ITEM: PUD-000519-2024 – 517 S Arthur Ave

REQUEST: Approval of Resolution No. 4, Series 2025, recommending approval of a Planned Unit Development Amendment to allow construction of a 16,294 square-foot industrial/flex building and associated site improvements.

RED GOLD BOTTLING CORPORATION PLANNED
UNIT DEVELOPMENT, 1ST AMENDMENT

CASE # PUD-000519-2024

East Elevation

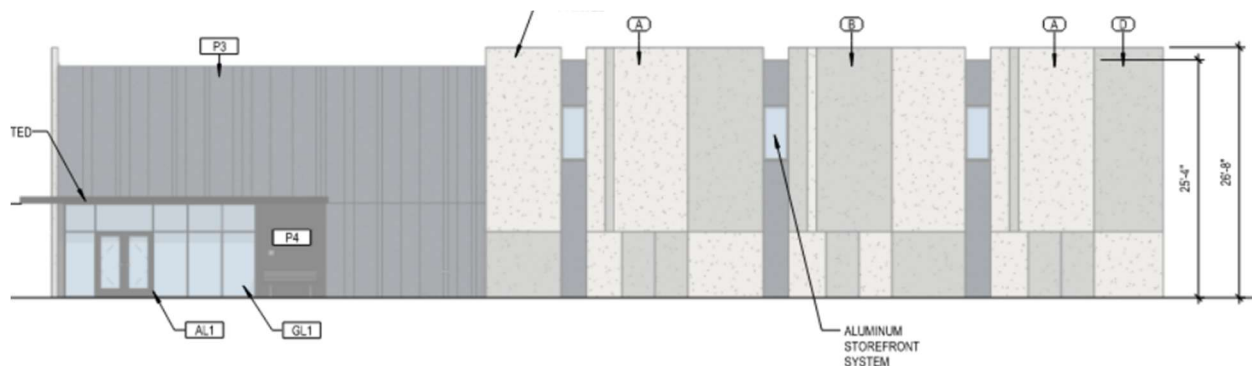
The building will be constructed of concrete tilt-up wall panels which are designed with varied patterns, form liners, and accent paint colors to provide the required design articulation in accordance with the IDDSG. The primary storefront entrance to the office area is highlighted by an open sunshade structure, while clerestory punched openings are located along the building's perimeter to enhance visual interest and provided daylighting. The elevations include variations in the parapet height and articulation in the building façade, which when combined with the variation in materials, create architectural interest and appropriate design for the Industrial zone district.

Setback Encroachment Exhibit

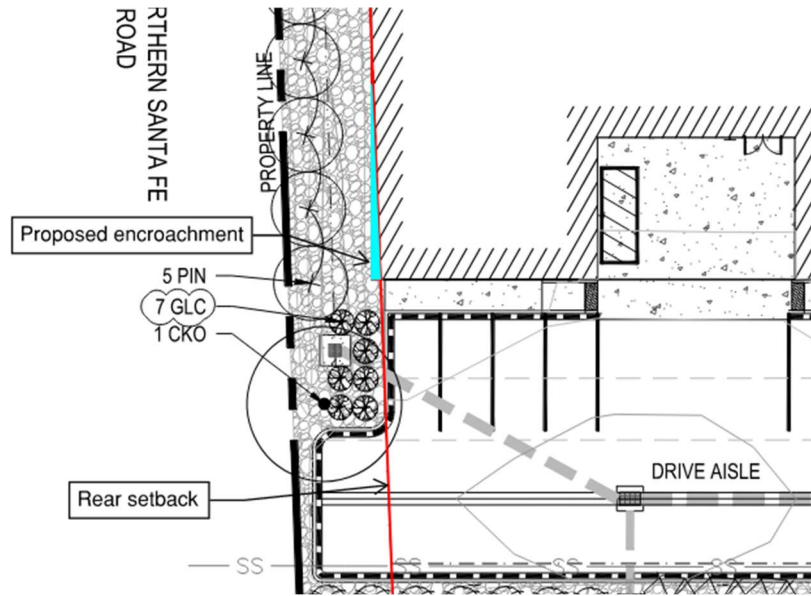
- Section 1.2 of the IDDSG requires a minimum rear setback of 15 feet, which in this case applies to the west side of the property. The applicant is requesting an encroachment of 1' 6" into the rear setback area at the southern end of the building.

This request is driven by the unique geometry of the lot. The property is configured with an oblique shape that tapers toward the south, creating a pinching point where the rear lot line converges with the building footprint. As a result, maintaining a consistent 15-foot setback along the entire rear façade presents a practical challenge without compromising the building's functional layout. The proposed encroachment is limited in scope and location, affecting a small portion of the building. The property to the west is BNSF rail line, so negative adjacent impacts are minimal. **Staff support the waiver as requested.**
